# **Field Safety Notice**

Reference: R546

This voluntary Field Safety Notice (FSN) is to inform you about a Field Safety Corrective Action (FSCA) for the AR-9800 Synergy RF Console.

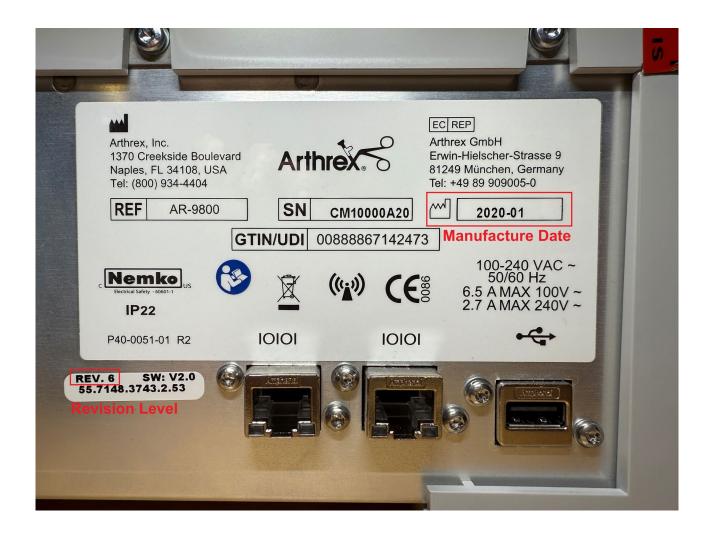
Upon initial power up of the AR-9800 there is a potential, with some electrical services, that an inrush current may occur. If this inrush current is to occur, there is a possibility that the circuit breaker trips. If the breaker trips, resetting the circuit breaker will be required to restore power. Other devices connected to the same electrical circuit would experience a temporary power outage until the circuit breaker is reset or the devices are connected to another power circuit.

Arthrex has identified 77 occurrences of complaints reporting breakers tripping for devices at Rev. 6 or below. The reported events have never resulted in harm to patients, users or third parties. Although no harm has been reported, it was determined that if a failure occurs, the worst potential outcome would be a failure to complete a procedure.

1. Immediately identify the indicated AR-9800 you have in your control. The affected devices can be identified via a label on the back of the device that indicates the revision level (see picture below). If the revision level label is not present, the device should be considered affected if the manufacturing date is prior to July 2020. The manufacturing date is indicated on the main label on the back of the device.

To resolve this issue, an Arthrex employee will replace the current T8A fuses with new F4A fuses and relabel the device with new fuse specifications.
